Work Order ID 107778

Item Name: Crosstube Turning Detail

DART AEROSPACE LTD	Work Order:	107778
Description: Crosstube Assembly	Part Number:	D407-667-145
Inspection Dwg: D407-667-145 Rev: C		Page 1 of 2

DRAWING NO. D407-667-145	TITLE CROSSTUBE ASS'Y (407 HIGH FWD)	REV. C	DART AEROSPACE LTD ENGINEERING ORDER		D.E.O. NO. D407-667-145-C-1	SHEET NO. SHEET 1 OF 1	SCALE NTS
DRAWN 90	CHECKED ASS	MFG. APPR. KB	APPROVED WD		DE APPR. H		
DATE 11.07.15	DATE 11.07.22	DATE 11.07.22	DATE 11/07/22		DATE 11.07.21

DETAIL P
BONDING STRAP INSTALLATION 2 PL

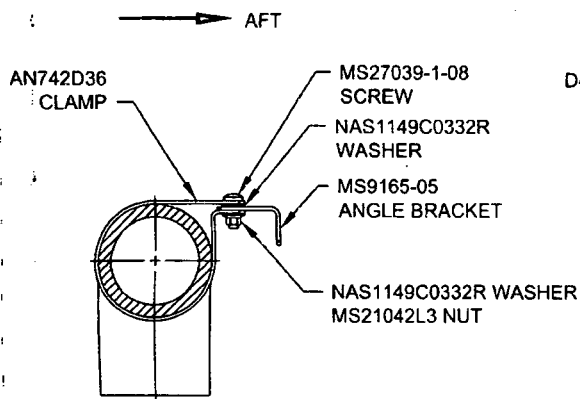
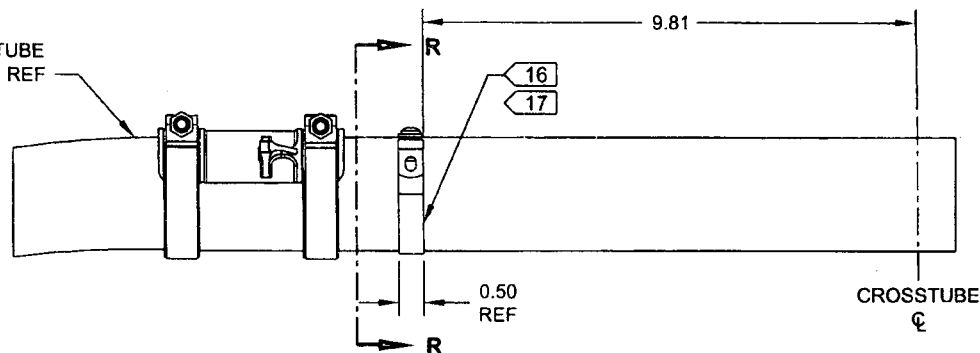
PURPOSE:

ADD ELECTRICAL GROUNDING STRAP

ITEM	QTY -145	PART NUMBER	DESCRIPTION
1	X	D407-667-145	CROSSTUBE ASSEMBLY (407 HIGH FWD)
10	2	AN742D36	CLAMP
11	2	MS9165-05	ANGLE BRACKET
12	2	MS21042L3	NUT (OR MS21042-3)
13	2	MS27039-1-08	SCREW
14	4	NAS1149C0332R	WASHER (OR AN960C10L)

ADD

- 16) MASK AREA UNDER CLAMP PRIOR TO PAINTING
- 17) SEAL EDGES WHERE AN742D36 CLAMP MEETS WITH THE CROSSTUBE USING SIKAFLEX-241/-291 OR MIL-S-8802 CLASS B2 OR PROSEAL 890 SEALANT
- 18) PERFORM RESISTANCE CHECK TO ENSURE MAX RESISTANCE IS 10 MILLIOHMS
